FORM APPROVED
OMB NO. 1004-0135
Expires: July 31, 2010**SUNDRY NOTICES AND REPORTS ON WELLS**
*Do not use this form for proposals to drill or to re-enter an abandoned well. Use form 3160-3 (APD) for such proposals.*5. Lease Serial No.
NMLC029338A

☒ Oil Well ☐ Gas Well ☐ Other8. Well Name and No.
GISSLER A 24

Burnett requests permission to deepen the Gissler A 24 well in the Loco Hills Yeso field in Eddy County to the base of the Yeso near 6150? TVD using United Drilling Rig #5.

Gissler A 24
30-015-33498
Burnet Oil Co.
June 03, 2014
Conditions of Approval

**BURNETT OIL COMPANY, INC.
BLOWOUT PREVENTER &
CHOKE MANIFOLD DIAGRAM
2000 PSI WORKING PRESSURE**

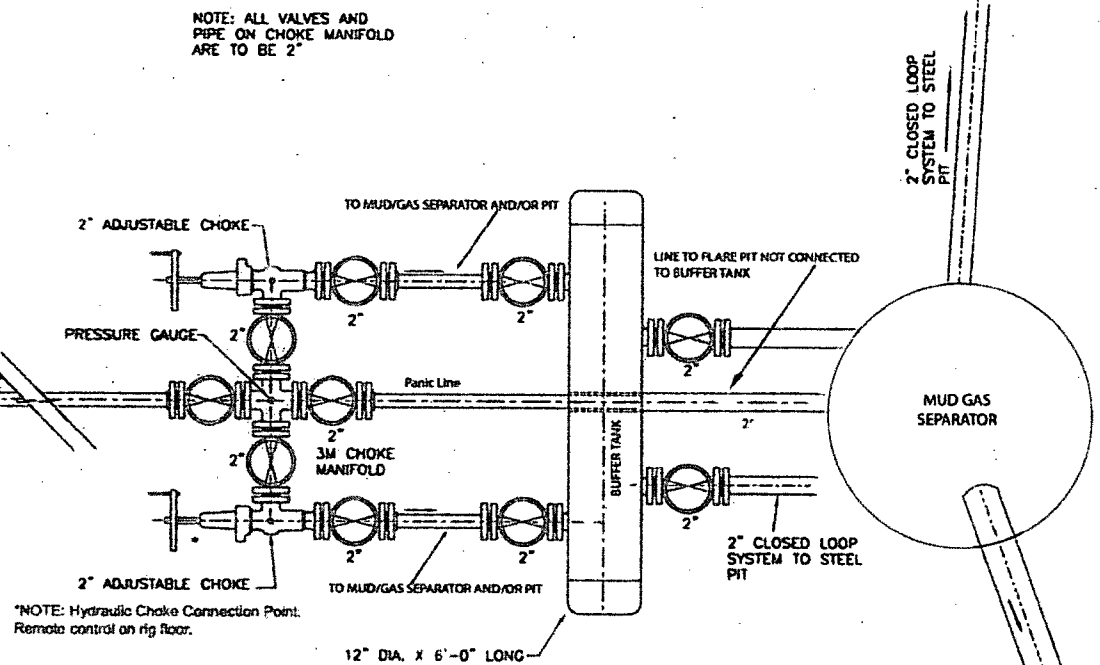
1. Work to be complete within 180 days.
2. Surface disturbance beyond the existing pad requires prior approval.
3. Closed loop system to be used.
4. H2S monitoring equipment should be onsite for personnel protection from surrounding oil operations. Operator should not encounter H2S while deepening.
5. BOP to be tested to **2000 psi** based on BHP expected.
6. Variance for stand-off of less than 0.422" is approved due to NMOCD classifying the formations in this area as the Yeso group.
7. Cement on liner shall tie back to liner top, if this is not achieved contact appropriate BLM office. When plugged, cement plug will be required across this tie back and across squeezed perforations.
8. Test casing as per Onshore Order 2.III.B.1.h.
9. Subsequent sundry detailing work and current well test data are to be submitted when work is complete.
